CENTRAL AND ROCK ADDITION WICHITA, SEDGWICK COUNTY, KANSAS

RE: SUB 2002-21 -- One-Step Final Plat of Central and Rock Addition

METROPOLITAN AREA PLANNING COMMISSION

CASE NUMBER: SUB 2002-21 -- CENTRAL AND ROCK ADDITION

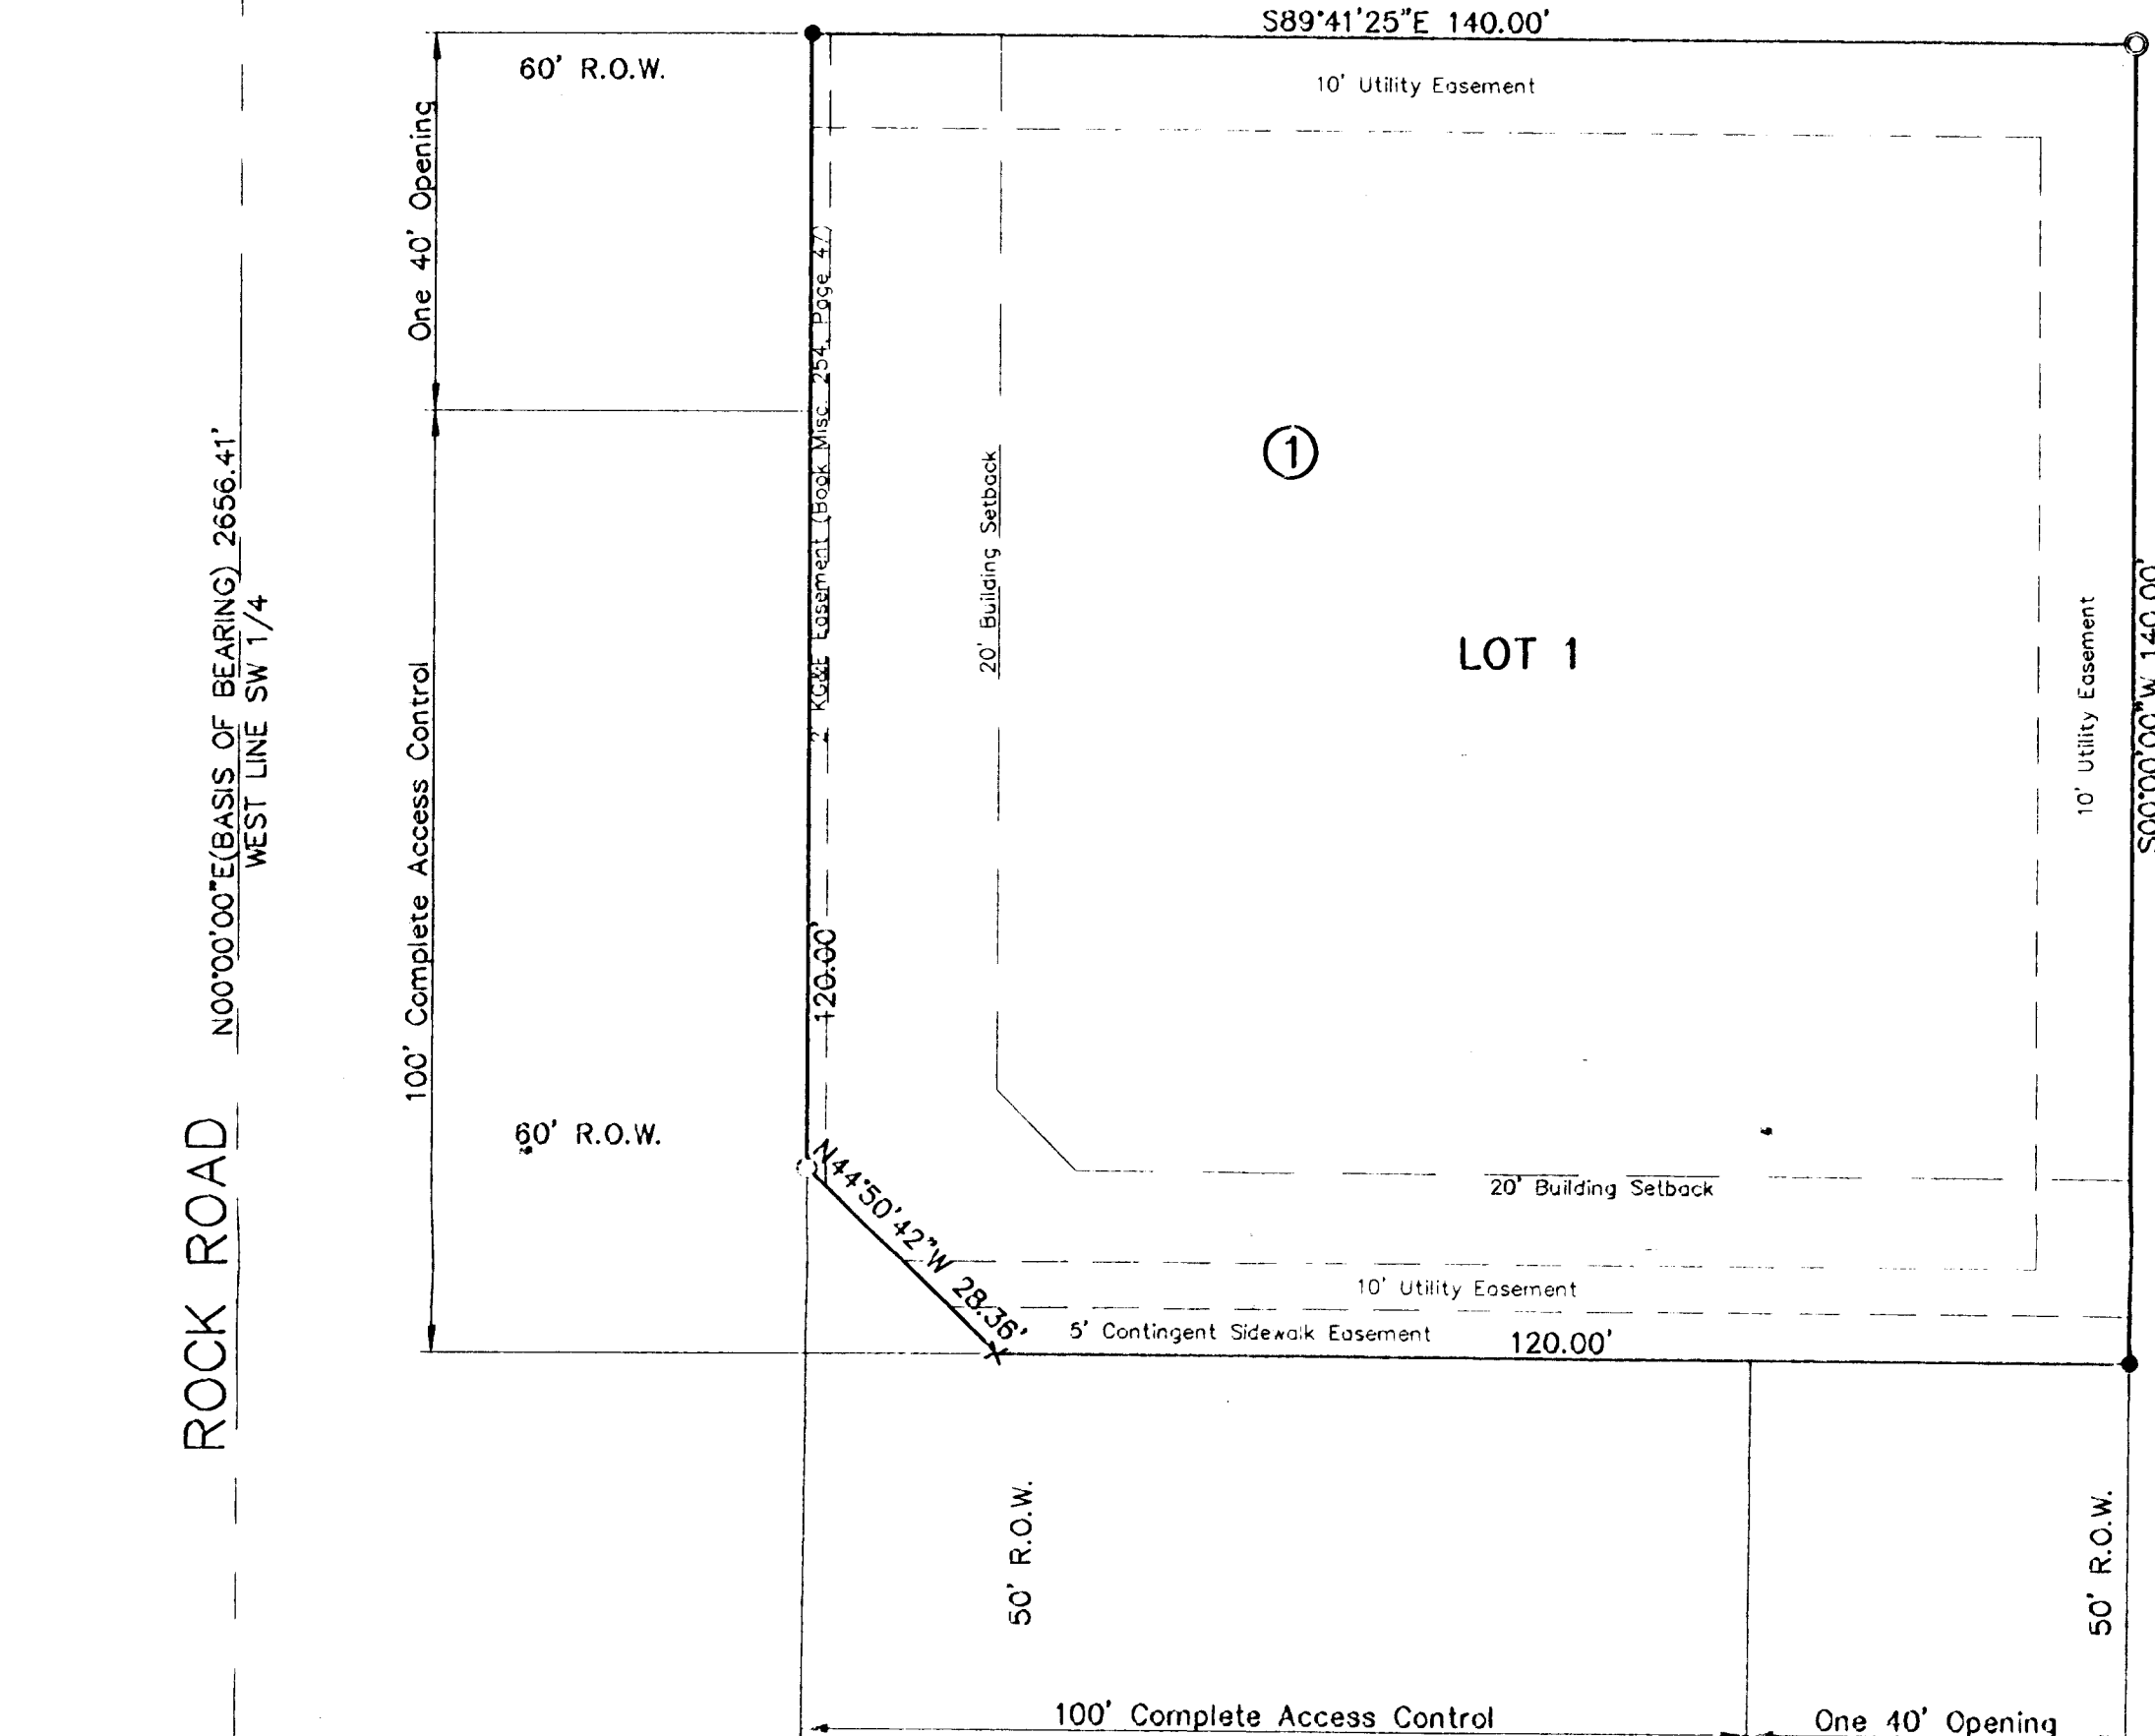
- A. Municipal services are available to serve the site. City Engineering needs to comment on the need for guarantees or easements. No guarantees or easements are required.
- B. If improvements are guaranteed by petition, a notarized certificate listing the petitions shall be submitted to the Planning Department for recording.
- C. City Engineering needs to comment on the status of the applicant's drainage plan. The drainage plan is approved.
- D. The plat proposes one access opening along both Central and Rock Road. Distances should be shown for all segments of access control. The proposed access openings have been approved. If a cross-lot access agreement can be obtained with the abutting properties to the east and north, then both driveways shall be closed. Traffic Engineering has requested that the opening along Central be limited to right turns only.

The Subdivision Committee approved full turning movements for the opening along Central.
- E. The applicant has platted a triangular corner clip with a 50-ft right-of-way along Central and a 60-ft right-of-way along Rock Road. Traffic Engineering has requested a 10-ft contingent street dedication.

- F. The applicant shall submit an avigational easement covering all of the subject plat and a restrictive covenant assuring that adequate construction methods will be used to minimize the effects of noise pollution in the habitable structures constructed on subject property.

- G. The owners noted in the platting binder need to be signatories to the plat.
- H. The platator's text shall include language that a drainage plan has been developed for the plat and that all drainage easements, rights-of-way, or reserves shall remain at established grades or as modified with the approval of the applicable City or County Engineer, and unobstructed to allow for the conveyance of stormwater.

- P. The representatives from the utility companies should be prepared to comment on the need for any additional utility easements to be platted on this property. **Southwestern Bell has requested additional easements.**

"A 5-foot contingent sidewalk dedication along Central is required, to be located within the required 10-ft utility easement."

In lieu of the contingent street dedication, the Subdivision Committee has required a 10-foot utility easement along Central.
